Farseeing Knit Composite Limited (Extension)

Faridpur, Telihati, Sreepur, Gazipur

10 January 2024

Observation-2: Undesignated storage on ground level suspended floor and 1st floor. (Building-1 (Production Building))

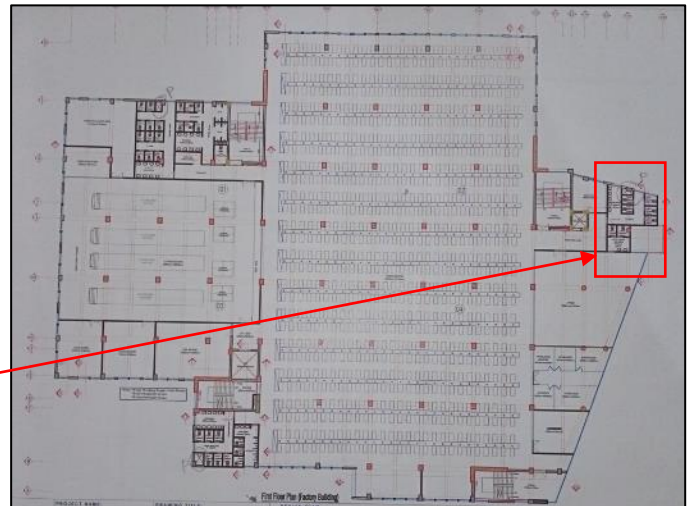
Description: Undesignated storage found on the suspended ground floor (above UGWR) and 1st floor. The building engineer is required to update the load plan considering 6 kPa for storage areas and check the design accordingly.
